STAFF RECOMMENDATION

918 Lawrence Avenue

August 19, 2020

Application: New Construction—Infill and Outbuilding
District: Waverly-Belmont Neighborhood Conservation Zoning Overlay
Council District: 07
Base Zoning: R8
Map and Parcel Number: 10513029600
Applicant: Josh Shambaugh, Nine 12 Architects
Project Lead: Melissa Baldock, melissa.baldock@nashville.gov.

SITE PLAN
 SCALE: 1/16"=1'-0"

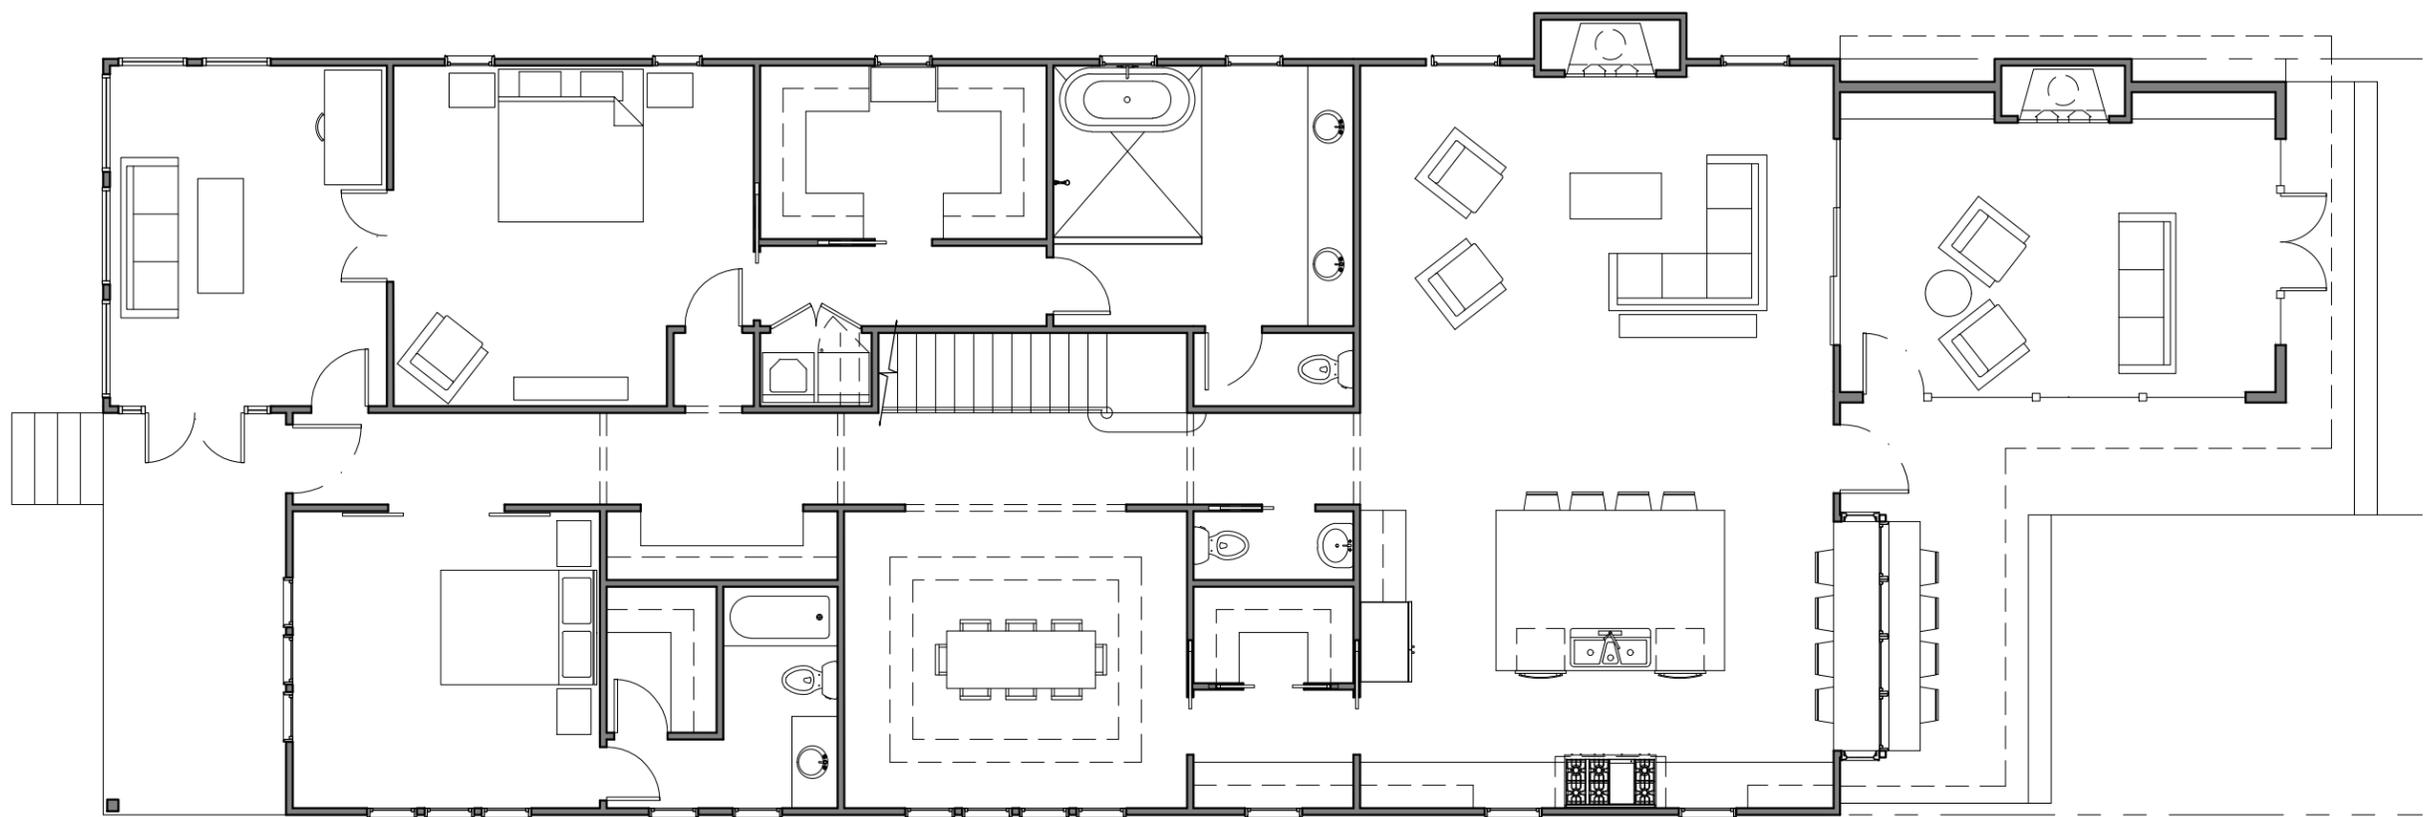
Setback & Rhythm of Spacing: The infill meets all base zoning setbacks. It will be centered on the lot and six feet (6') from each side property line. It will be forty-seven feet, six inches (47'6") from the rear property line, and there will be at least twenty feet (20') between the back of the house and the outbuilding.

Staff finds that the proposed infill's setback and rhythm of spacing meets Section III.C. of the design guidelines.

ROOF PLAN

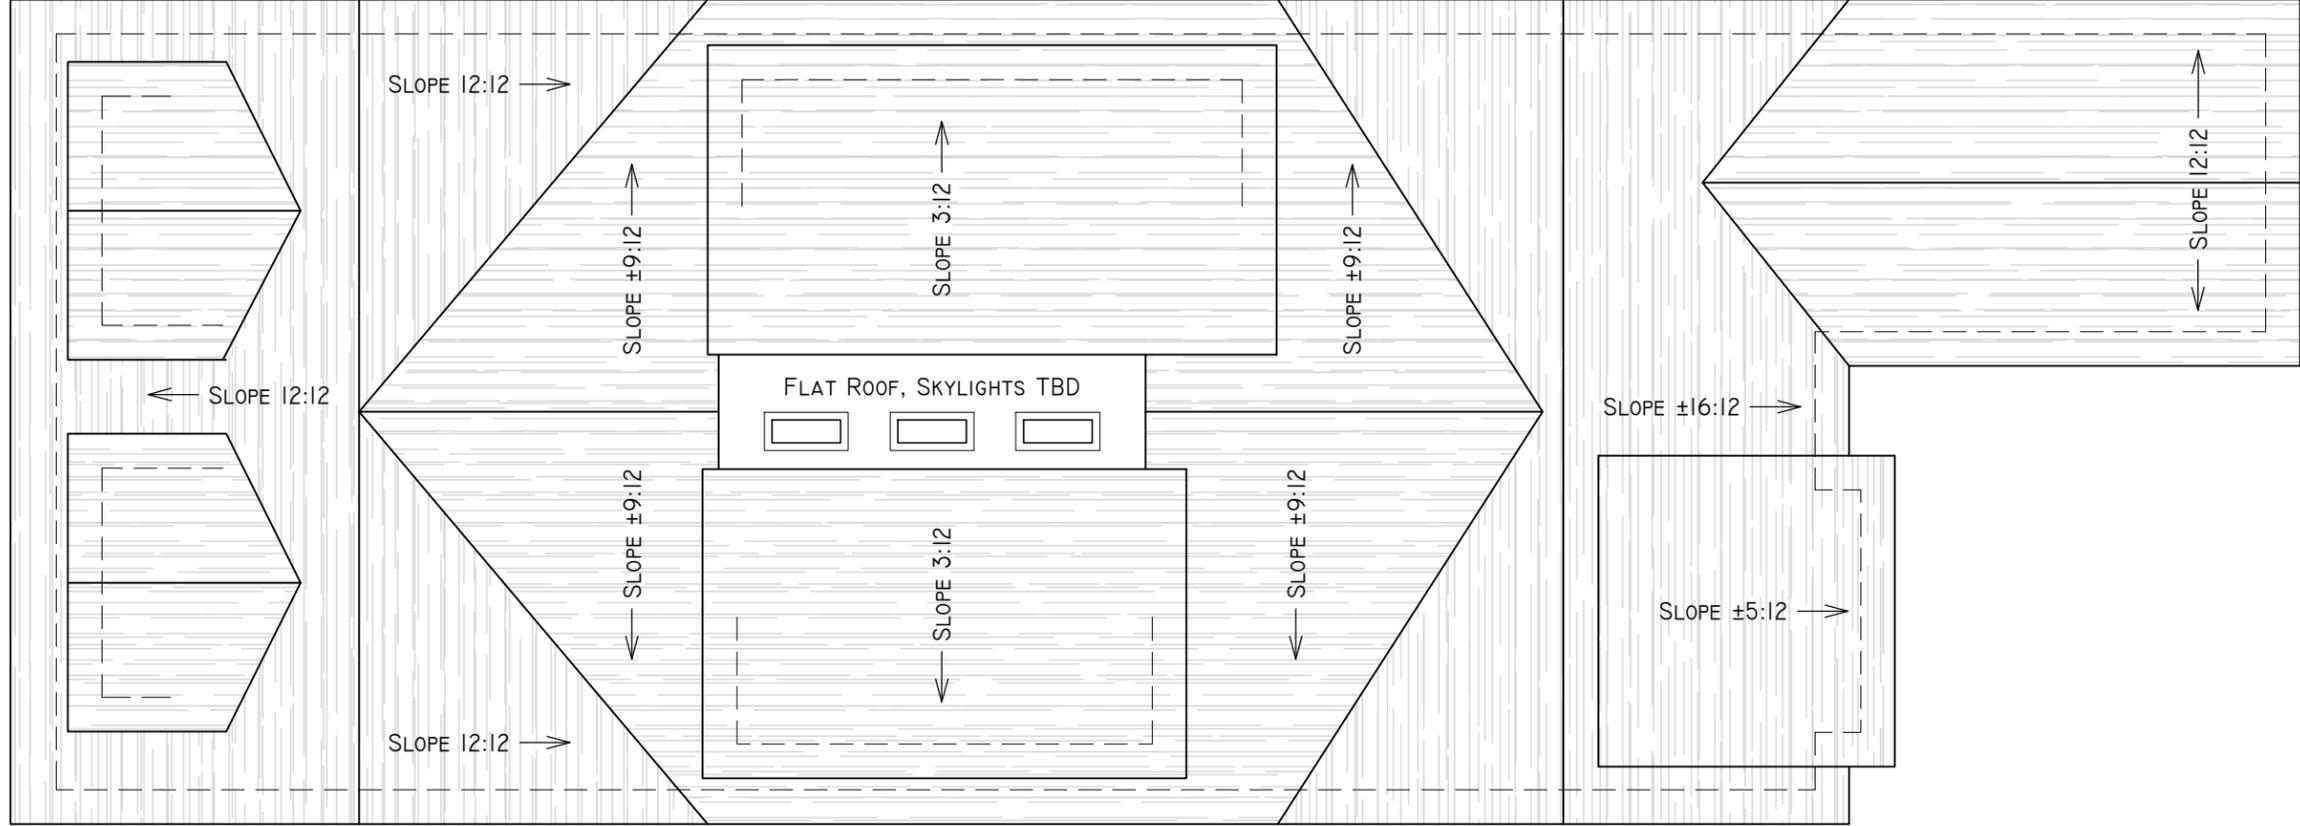
Roof form: The house has two side gable forms connected by gables. The front gable has a 12/12 slope, the connector has a 9/12 slope, and the rear gable has a 16/12 slope. The front façade has two gabled dormers that are set back two feet (2') from the wall below. The rear porch is a one-story 12/12 gable, and there is a 5/12 rear shed dormer. These roof forms meet the historic context and the design guidelines.

Staff finds that the proposed roof forms meet Section III.E. of the design guidelines.

BUILDING
 ELEVATIONS
06

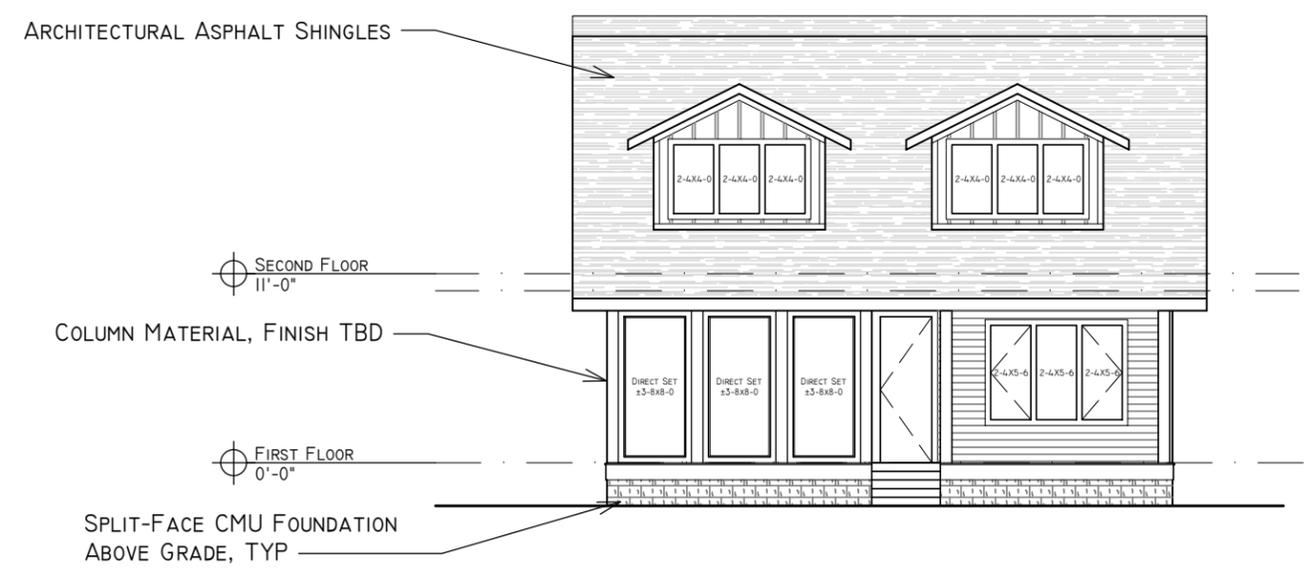
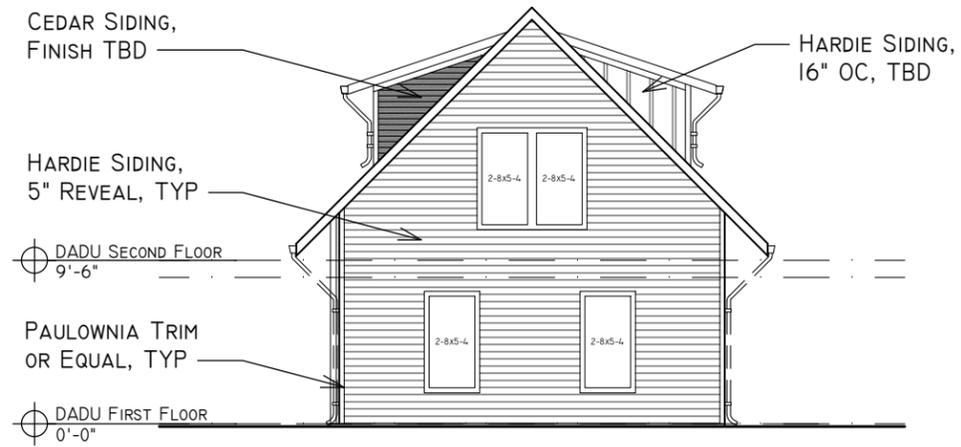
Height & Scale: The proposed infill is one-and-a-half stories, which meets the immediate historic context. The house will have an overall height of twenty-six feet, six inches (26'6"), which is similar to the historic houses in the immediate vicinity.

Proportion and Rhythm of Openings: The windows on the proposed infill are all generally twice as tall as they are wide, thereby meeting the historic proportions of openings. There are no large expanses of wall space without a window or door opening. The left side of the front porch is largely glass, similar to a sun room. Staff finds this to meet the design guidelines.

Staff finds the project's proportion and rhythm of openings to meet Section III.G. for new construction-proportion and rhythm of openings.

DADU
ELEVATIONS

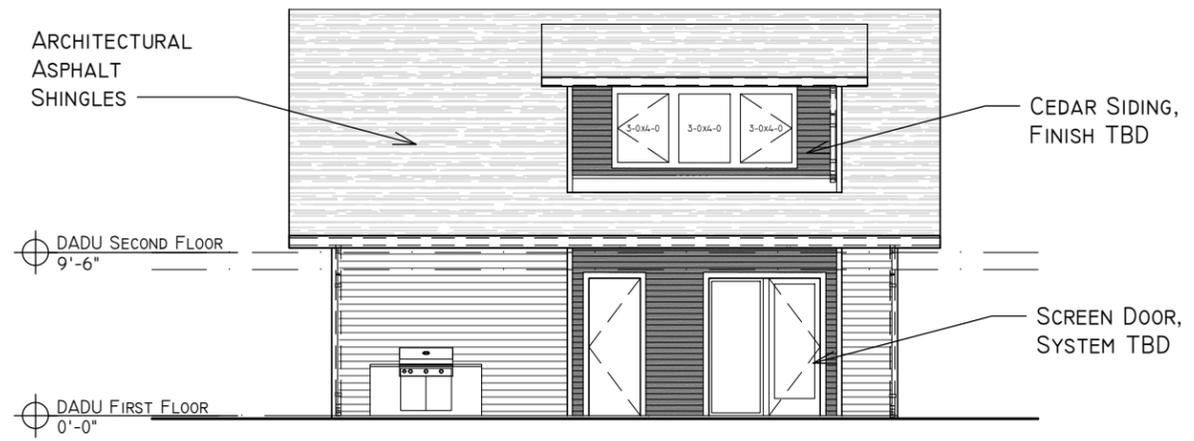
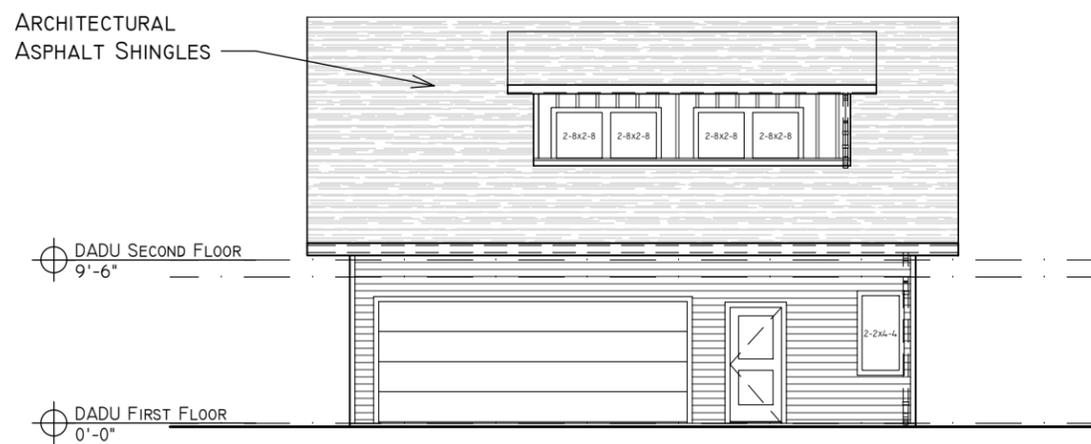
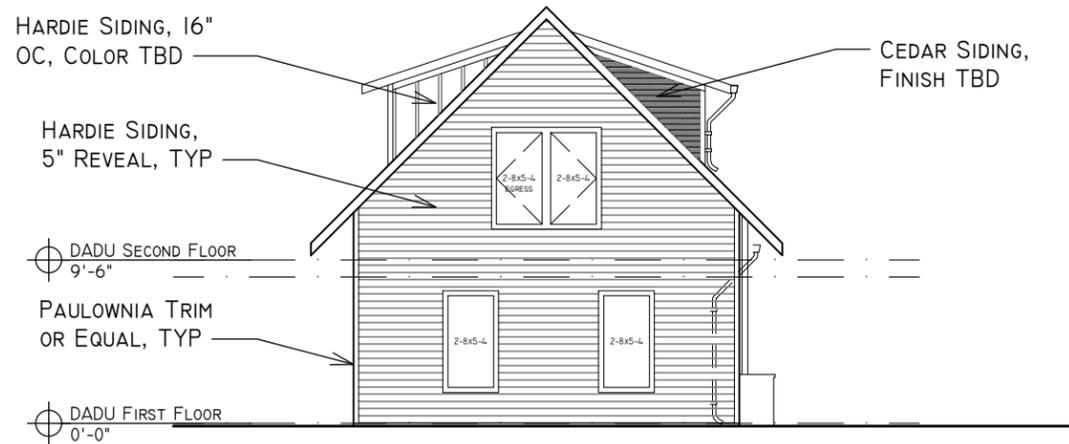
Potential maximums under Ordinance	Infill	Proposed Outbuilding
Ridge Height	25' unless existing building is less	26'6"	23'9"
Eave Height	10'	10'	9'6"

Proposed Element	Proposed Form	Typical of district?
Primary form	Gable	Yes
Primary roof slope	12/12	Yes
Dormers	Shed	Yes
Dormer slope	4/12	Yes

Staff finds that the proposed outbuilding meets Section III.H.1.c of the design guidelines for height and scale.

Staff finds that the outbuilding's roof form meets Section III.H.3 of the design guidelines for roof shape.
